# Ute Mountain Ute Tribe

Re: Public Comment on  
Amendment Radioactive Materials License No. UT 1900479  
Amendment of the Groundwater Quality Discharge Permit No. UGW370004  
Energy Fuels Resources (USA), Inc., White Mesa Uranium Mill, San Juan County, Utah

## Ute Mountain Ute Tribe Response to EFRI Sur Reply Comments

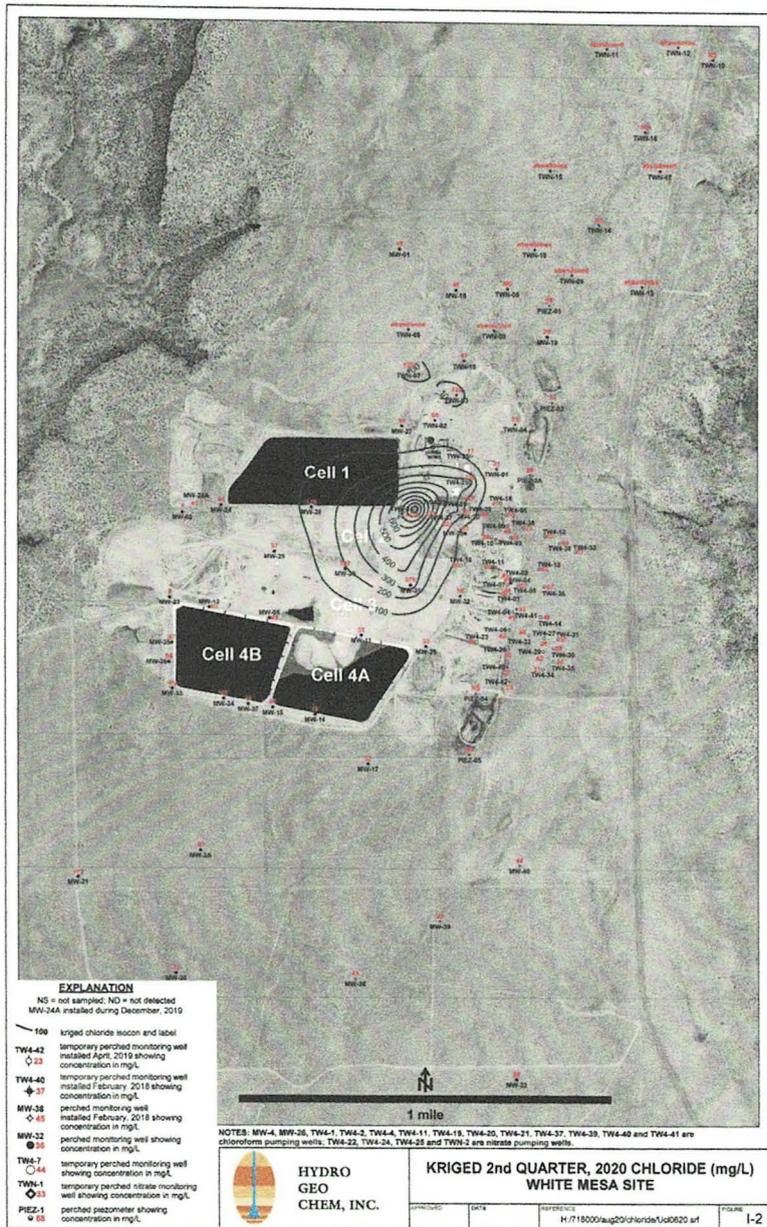
The fact is that the water quality of the Burro Canyon aquifer in the vicinity of the Mill facility is rapidly degrading to levels that exceed protective criteria - criteria the State has established to protect our valuable and irreplaceable water resources and human health and the environment. Quarterly groundwater reports (EFRI 2020a, EFRI 2020b, EFRI 2020c) document that groundwater quality is getting worse month by month. The theories advanced by EFRI that the adverse changes are due to an upgradient source or to a natural phenomenon involving pyrite remain unlikely and unproven. Both theories depend on unsubstantiated assertions that EFRI refuses to prove with updated isotopic testing. Both theories ignore risk-based analyses of metals which have increased to toxic levels (cadmium, selenium, thallium, uranium) to potential receptors. In many cases levels of toxic metals are being allowed to exceed MCLs, with no corresponding risk-based analysis of potential adverse impacts to the environment or public health and safety. Environmental health, the health of nearby residents and future generations, and the preservation of the Burro Canyon aquifer as a groundwater resource are threatened by the degrading quality of the of the shallow groundwater at the Mill site, contrary to the objectives of the Utah Groundwater Protection Program. The Division must require that the source(s) of the continuing unabated negative trends in the Burro Canyon aquifer be investigated, positively identified and addressed. The Division must not allow further relaxation of GWCLS without requiring a risk-based evaluation of the impacts from the degradation that is being allowed to occur and ensuring that compliance levels are protective of human health and the environment.
